WCAP-15872-NP-A, Rev. 0

**Subject: Westinghouse Owners Group
Transmittal of NRC-Approved Topical Report WCAP-15872-NP-A, Rev 0, (Non-Proprietary) "Use of Alternate Decay Heat Removal in Mode 6 Refueling," (TAC MB9020) (Task 2075)**

Reference: 1. Letter, H. Berkow (NRC) to G. Bischoff (WOG), "Final Safety Evaluation for Topical Report WCAP-15872-NP, Rev 00, "Use of Alternate Decay Heat Removal in Mode 6 Refueling (TAC No. MB9020)" dated November 30, 2004.

Figure A-3
Sample Cases: Average Refueling Pool Temperature

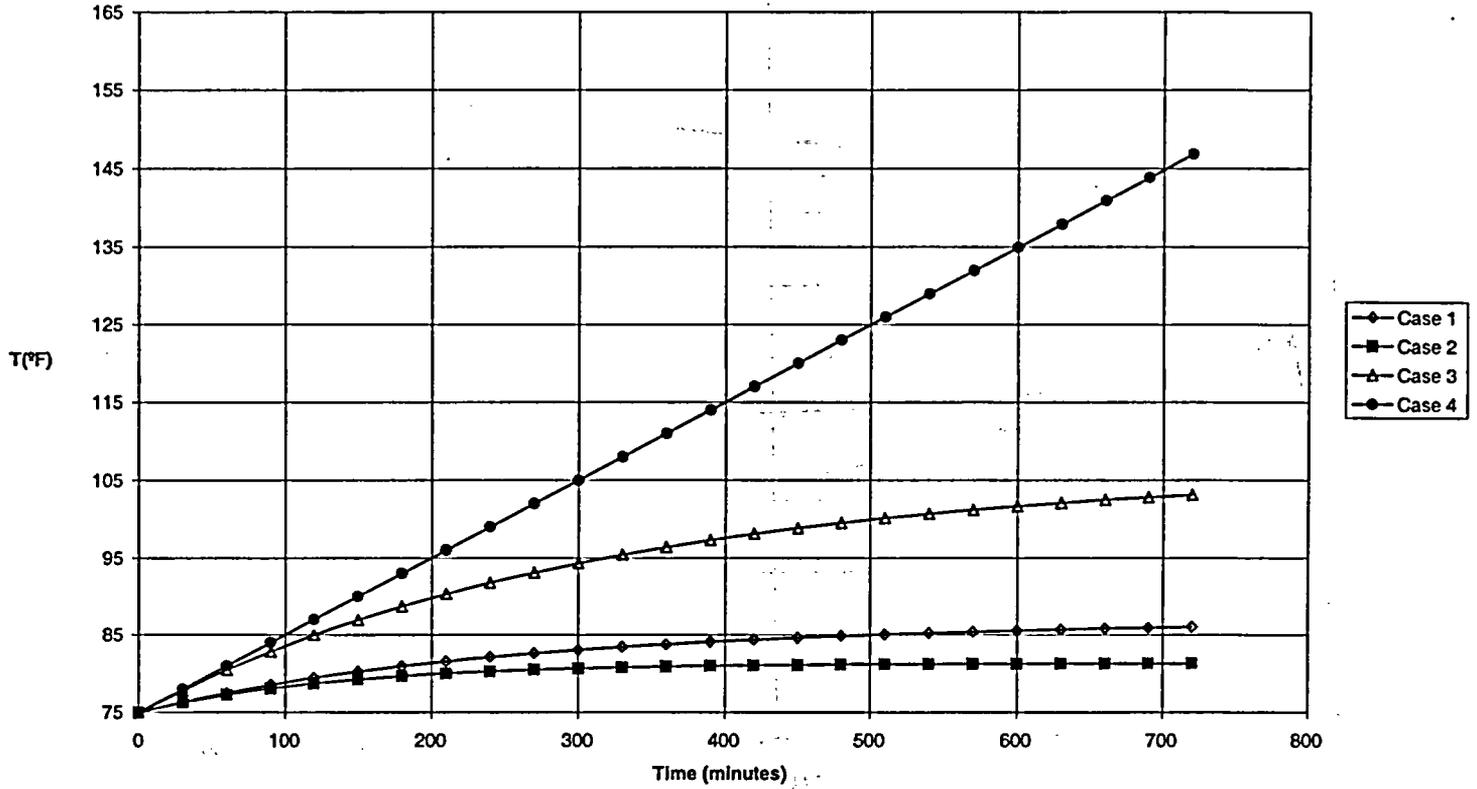
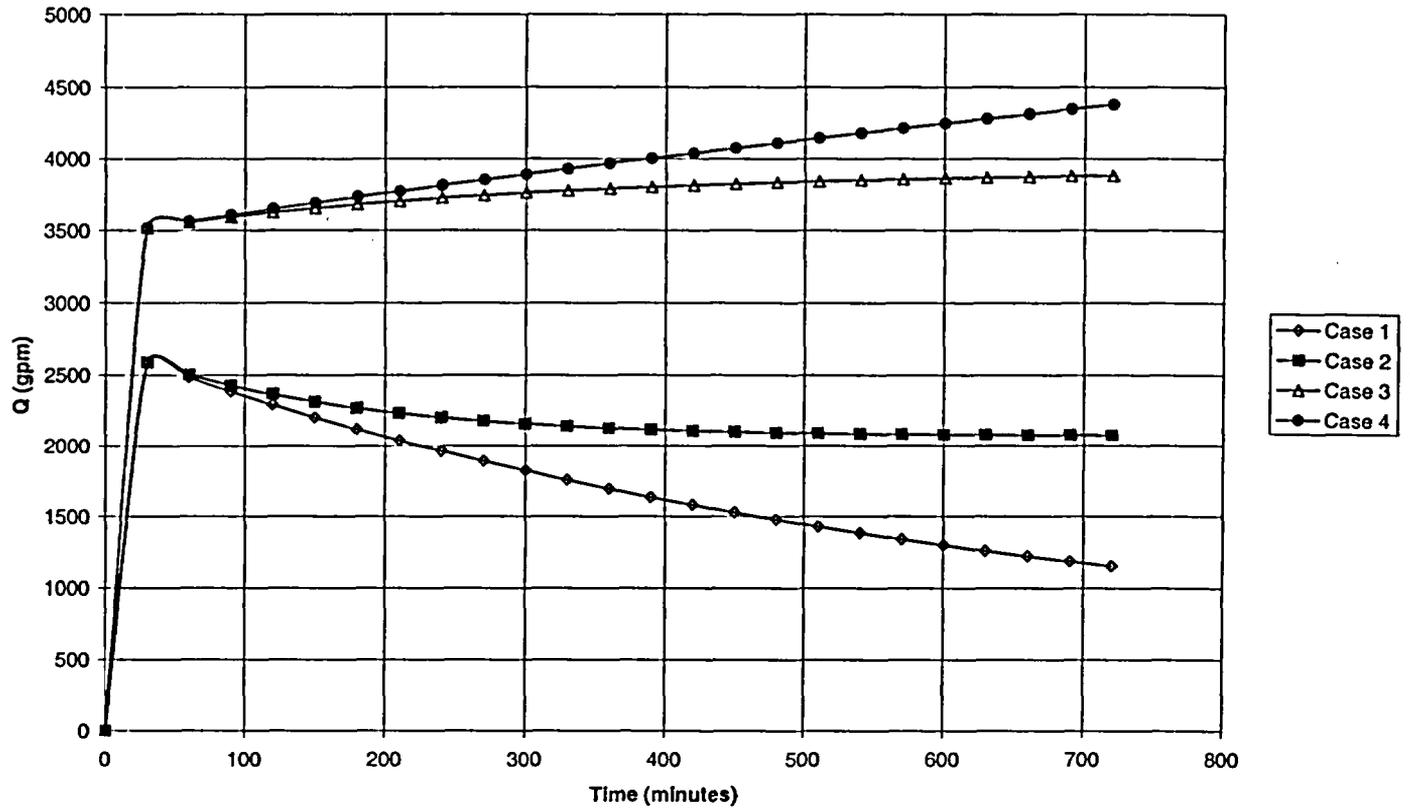
RAI A7. Please show the derivation of the values of ϵ_{mix} and ϵ_{bypass} used in the results shown in Figs. A-3 and A-4 for Case 2 and Case 3.

The mixing and bypass coefficients are defined in Appendix A and derived as shown in Appendix D. However, for the results shown in Figure A-3 and Figure A-4, these coefficients were assumed well mixed, i.e., $\epsilon_{mix} = 1.0$ and all alternate heat removal flow fully mixed with the natural convection flow from the core, $\epsilon_{bypass} = 0.0$. In Appendix A, Case 2 represents full SDC flow plus alternate cooling flow; Case 3 represents only alternate cooling flow. (Note that sample Cases 1 – 4 in Appendix A are not the same as test Cases 1 – 4 listed in Appendices B, C and D.)

Figure B-1
CCNPP Unit 2 Outage Tests: Flow Alignments

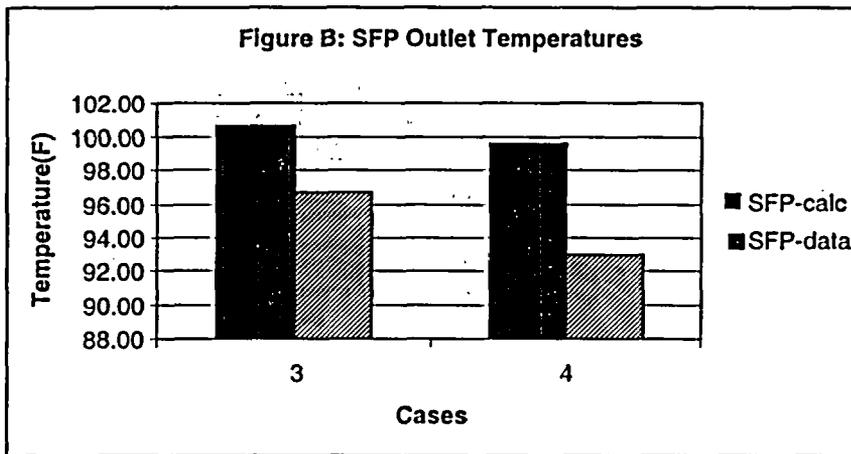
RAI B1. Fig. B-1 is confusing. Under the alternate cooling alignment do you have a separate spent fuel pool (SFP) pump and heat exchanger for both the refueling pool and the SFP, or do these represent separate alignments? Please indicate the complete flow paths of fluid associated both with the refueling pool and core, and the SFP. In your figure, how and when do you get flow "from the refueling pool to the spent fuel pool?"

Figure B-1 illustrates the specific alternate heat removal alignment at CCNPP. The figure describes the capability to align a "spare" spent fuel pool cooling train to cool the refueling pool while a second train remains aligned to the site's spent fuel pool.

The actual configuration of the alternate cooling alignment implemented at other plants may vary depending upon the available plant equipment capabilities. Refer also to Figure 1 of WCAP-15872 which illustrates a generic shutdown cooling decay heat removal system, and to Figure 2 which illustrates the decay heat removal flow path when using the Alternate Heat Removal process. A different alternate heat removal alignment may be selected by other plants, depending on the heat removal loops available to cool the refueling pool. The alternate heat removal process does not envision altering the traditional method of cooling the spent fuel pool.

Figure D-2
Flow Paths for Bypass Flow

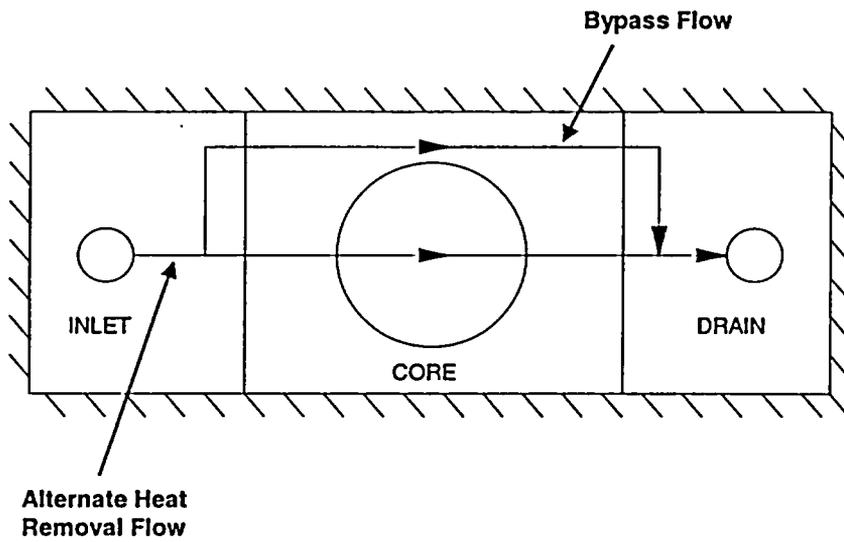
RAI D1. Please describe the simplified one-dimensional computational model and its relation to the two-dimensional computational fluid dynamics model. How does it differ from the one-dimensional model discussed in Appendix A? When you say "computational fluid dynamics model" (without the adjective "one-dimensional") in D.3, what are you referring to - A 3D model? Figures D-3 through D-6 give 2D results. So, how are you treating the situation in Figure D-2?

The mixing and bypass coefficients reflect three-dimensional effects into the one-dimensional analysis, shown in Appendix A, for natural circulation flow rates and refueling pool temperatures. The mixing coefficient is a measure of the uniformity of the refueling pool temperature, while the bypass coefficient, represented schematically in Figure D-2, is an indicator of the flow rate from the alternate cooling alignment that bypasses the natural circulation plume from the core.

Figure E-3

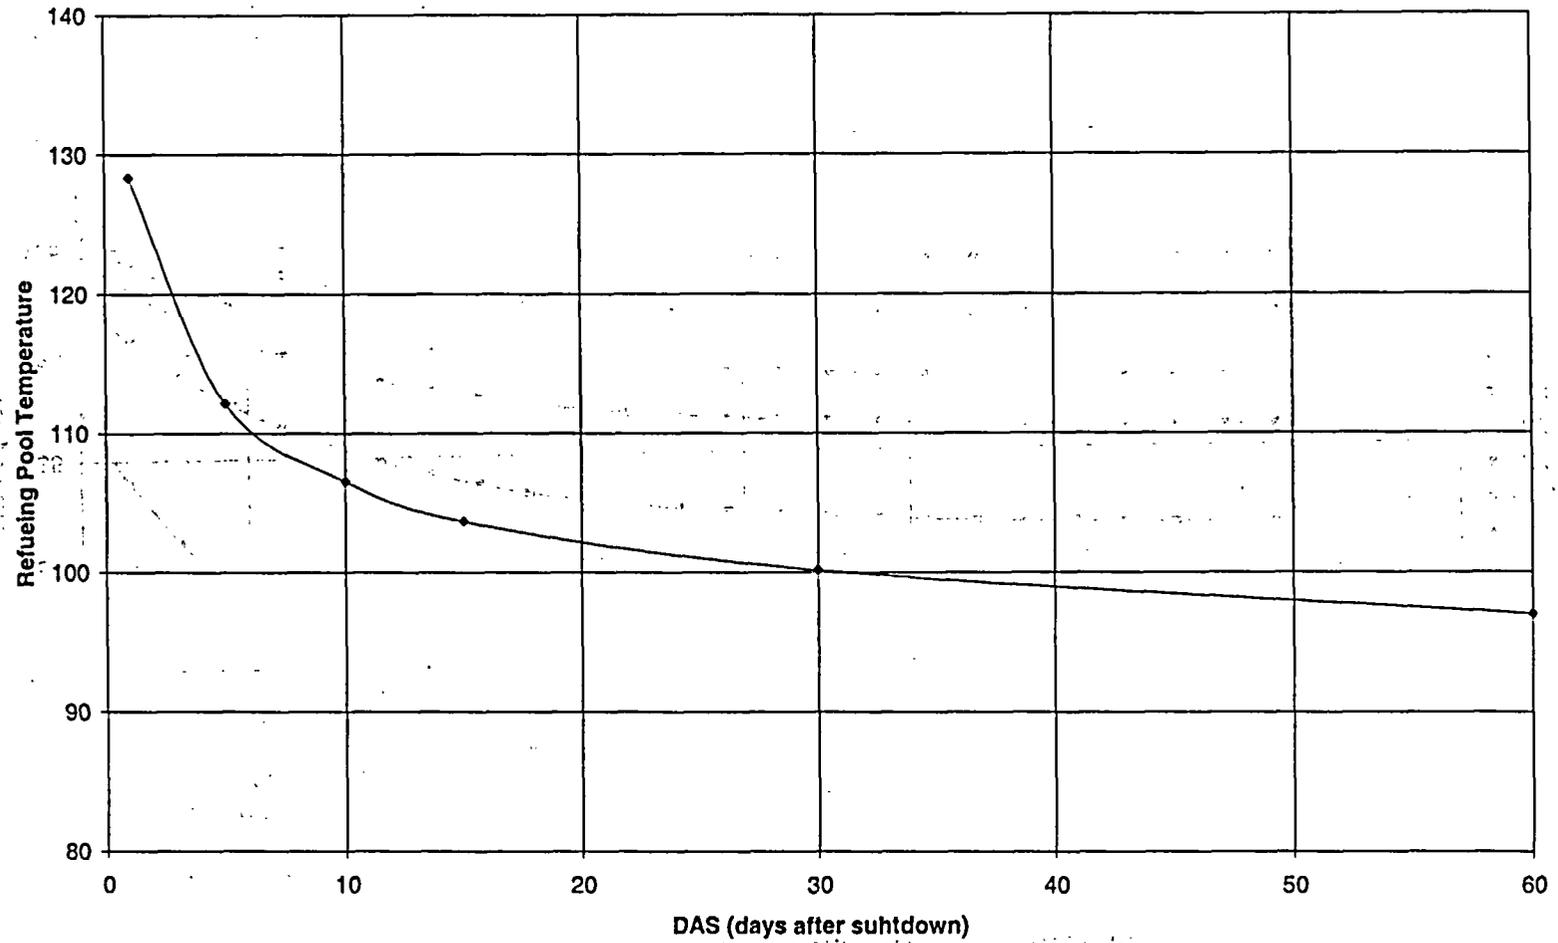
RAI E1. In section E.1, your discussion of Figure E-3 is inconsistent with the text. The text indicates that the initial refueling pool temperature is 75°F, while the value in the figure at t = 0 is 90°F.

The initial temperature of the refueling pool was taken as 90°F in the analysis. Page E3 of Appendix E has been corrected to be consistent with Figure E-3.

Figure E-5

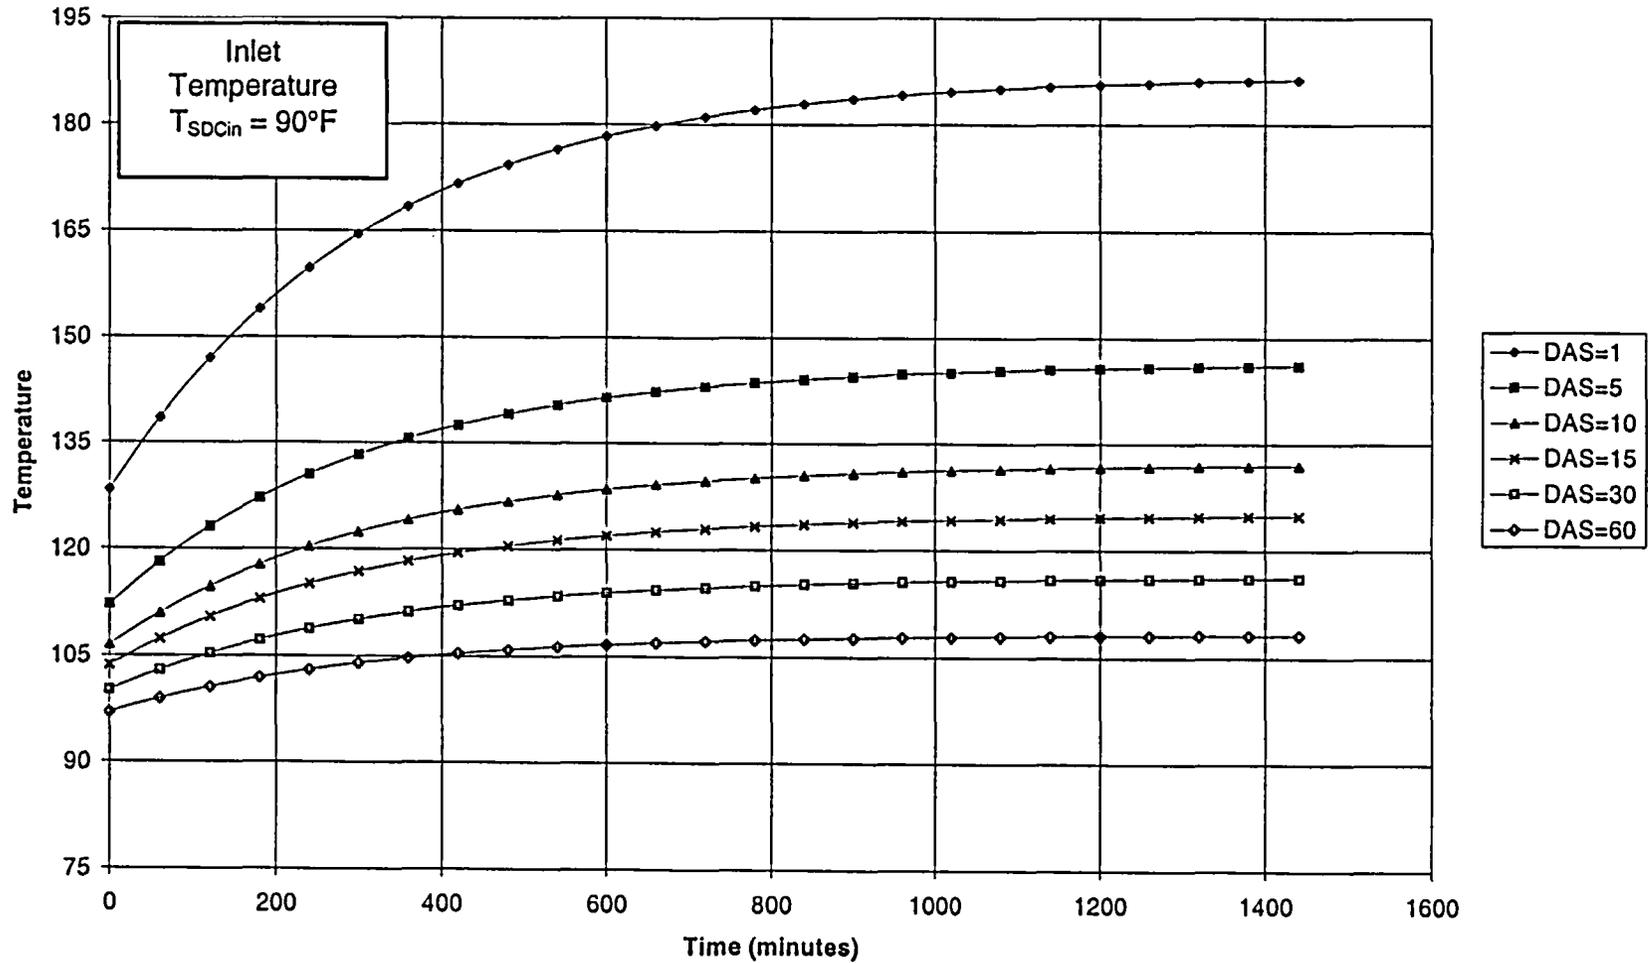
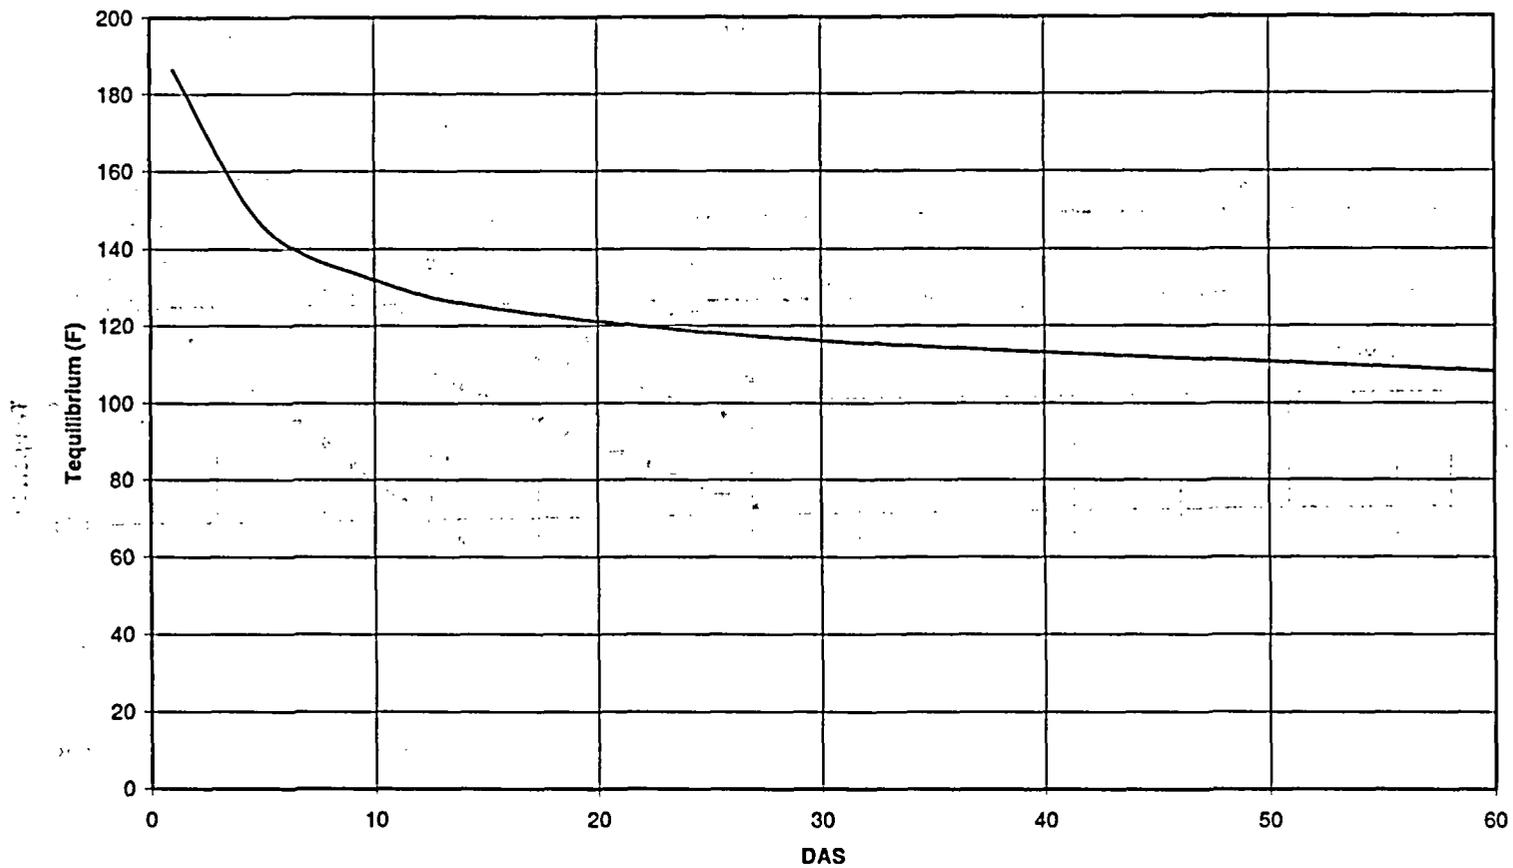
RAI E4. In the paragraph Limiting THS vs. TAS on page E4, Figure E-5 does not show a family of curves. What do you mean by a 90°F heat sink temperature when the refueling pool inlet temperature is also 90°F?

The statement has been corrected to refer to Figure E-4, not E-5. Figure E-5 is a cross-plot of the data shown on Figure E-4. The heat sink statement refers to the temperature of the heat sink for heat removal, which in this case is the inlet temperature to the spent fuel pool heat exchanger.
